County of Fairfax, Virginia

Re: Interpretation for SPA 76-A-022-2, Wakefield Chapel Recreation Association, Inc., Tax Map 70-1 ((1)) 16
(4627 Holborn Avenue): Tennis court reduction

Re: Letter of Interpretation
Wakefield Chapel Recreation Association, Inc.
PO Box 1248, Springfield, VA 22151
Tax Map: 70-1((1)) 16
Special Permit: SPA 76-A-022-02

FIELD VERIFIED RPA
BOUNDARY PLAN
BC67-RPA-01-1

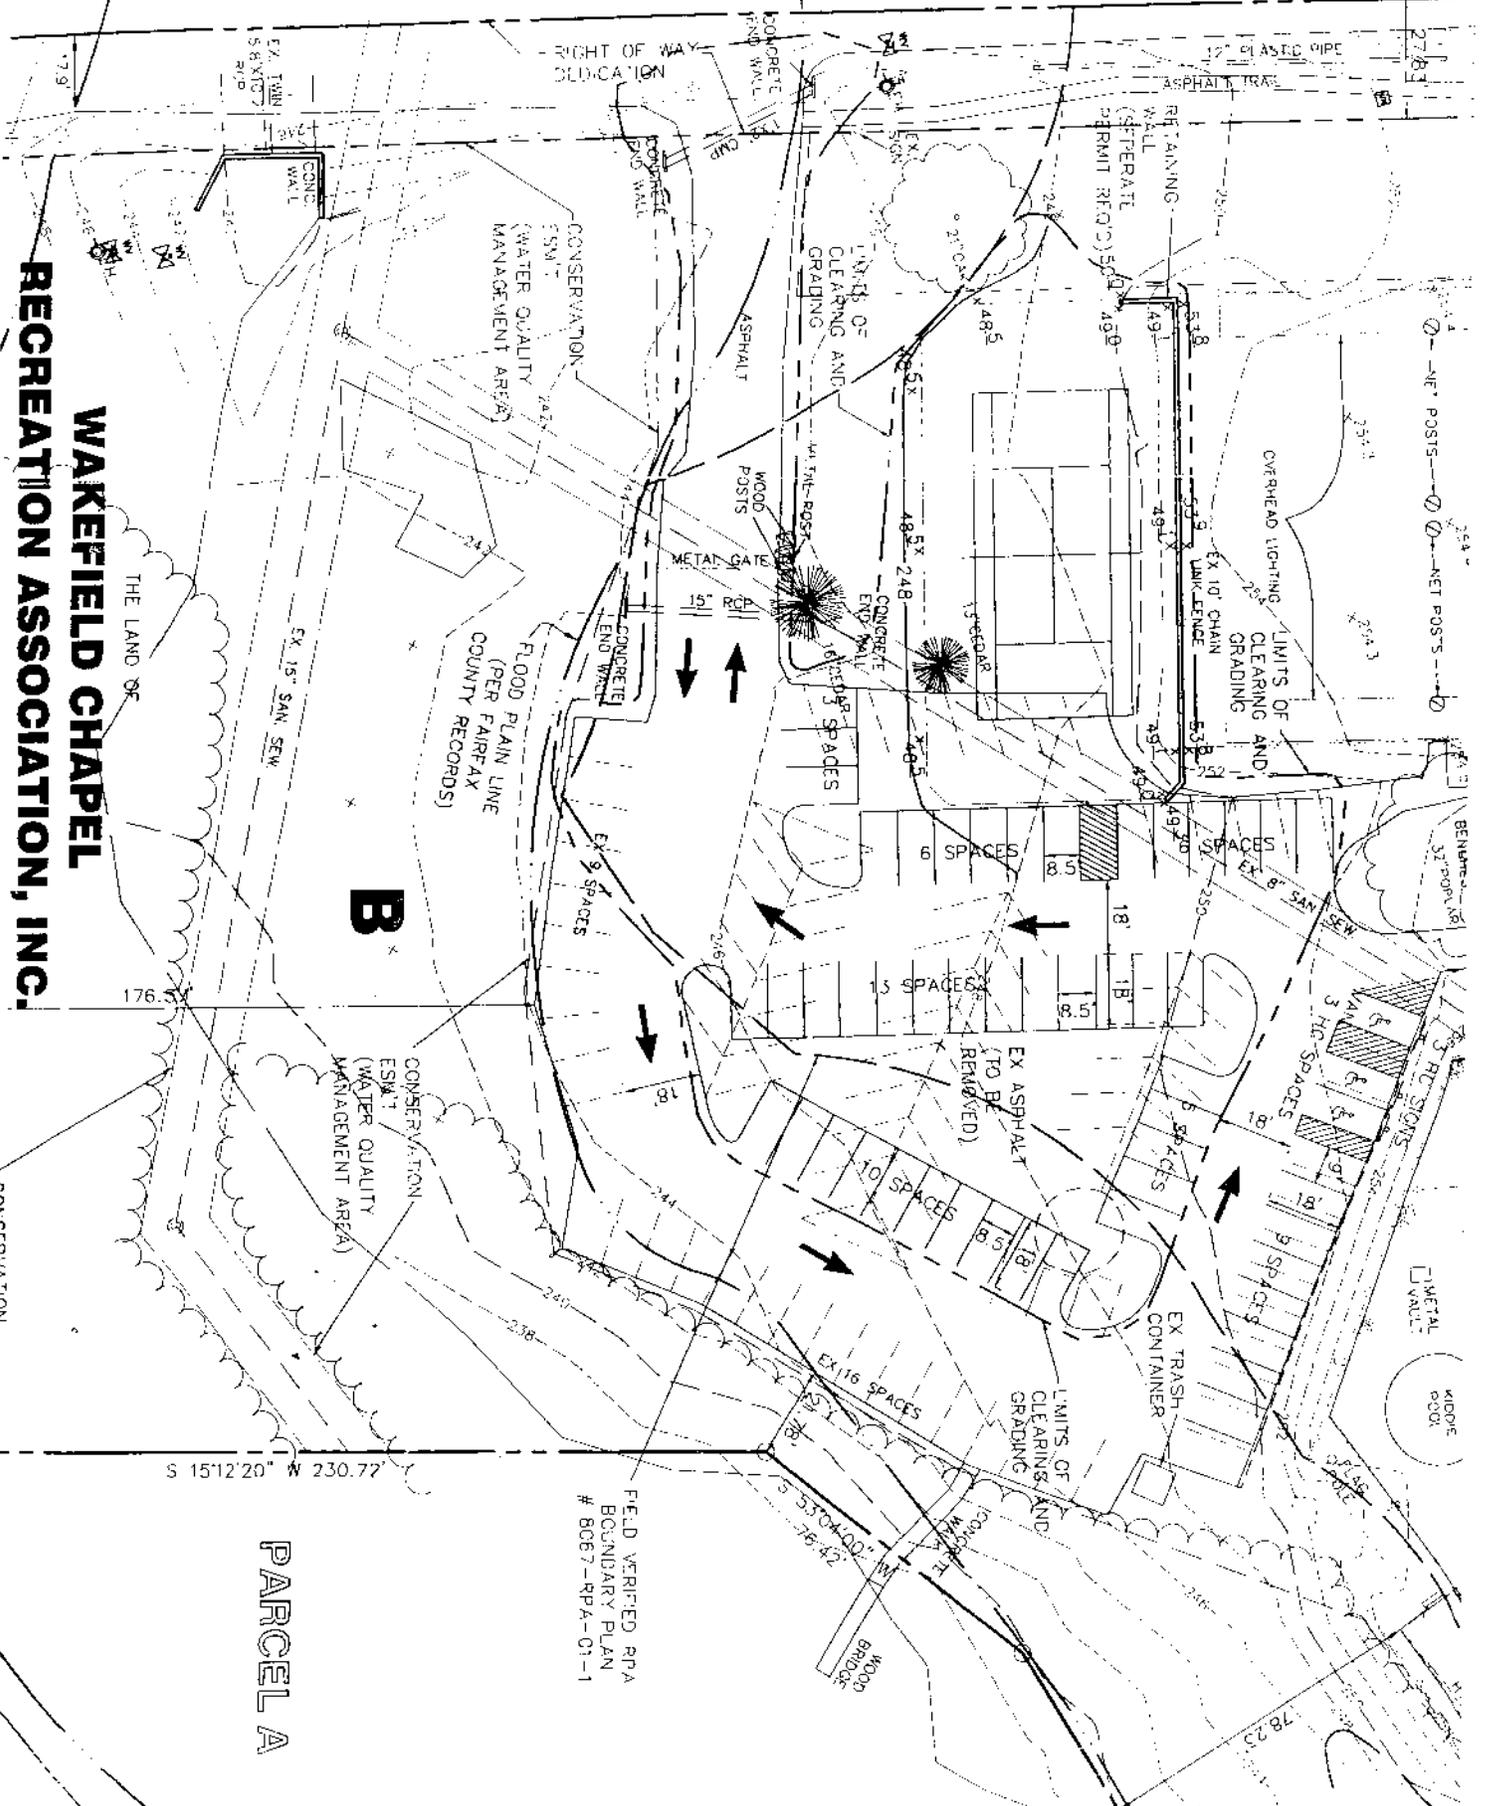
According to your letter, in order to reduce impacts on the Resource Protection Area (RPA) and post-development runoff, you have decided to eliminate one of the additional tennis courts that were approved pursuant to SPA 76-A-022-2. Your exhibit shows the proposed tennis court rotated 90 degrees. The tennis court is proposed to be constructed within the area that was approved for the construction of two additional tennis courts. There is no change in the limits of clearing and grading. The existing tennis courts are not proposed to change. In addition, your exhibit shows a retaining wall located north of the additional tennis court which appears to be approximately 4-5 feet in height. This retaining wall was not shown on the SPA Plat. A note indicates that a separate permit will be required for the retaining wall. You have stated that the wall will be constructed of keystone as shown on the KEYSTONE exhibit and that its maximum height will be 5 feet.

Wakefield Chapel Recreation Association is asking to receive a letter of interpretation for SPA 76-A-022-02. The referenced Special Permit (as amended November 2004) needs to be modified to reflect our decision to reduce the number of proposed additional tennis courts from two, which are shown on the special permit application, to one, which is shown on the site plan 8067-SP-01. (The facility currently has two courts and they will remain in place. We had planned on adding two more courts, and that plan was approved in 2004. We are now reducing our addition to one court, which will leave a total of three courts on the property.)

The change was made to reduce the impact to the Resource Protection Area as well as to reduce the post-development runoff. It was the engineer's opinion (Huntley, Nyce & Associates) that it would be difficult to comply with Fairfax County Storm Water Management and Chesapeake Bay Preservation ordinances if the two additional courts were constructed as shown on the Amended Special Permit. Please see the attached Site Plan sheets for graphical representation of the changes.

It is my determination that the elimination of one (1) of the two (2) approved additional tennis courts, and construction of a keystone retaining wall having a maximum height of 5 feet and located as shown on the submitted exhibit are in substantial conformance with SPA 76-A-022-2. This determination has been made in my capacity as the duly authorized agent of the Zoning Administrator. If you have any questions regarding this interpretation, please contact Mary Ann Godfrey at (703) 324-1290.
